PR-2022-007507

PA-2025-00168 – SKETCH

REQUEST: To create two lots from one lot and vacate easements and grant easements as shown on the plat

Development Facilitation Team (DFT) – Review Comments

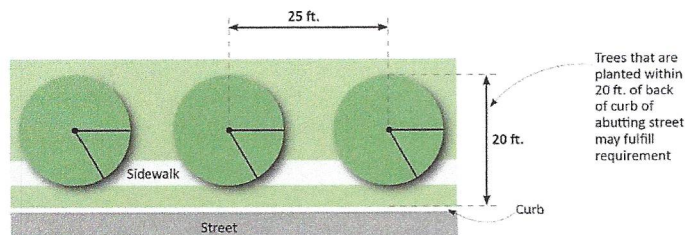
- Subject property is adjacent to the North Diversion Channel and North Diversion Channel Trail.
- For future development, design requirements related to being adjacent to a City trail must be considered.
- For future development street trees will be required along Pan American Freeway per the IDO and the Street Tree Ordinance.
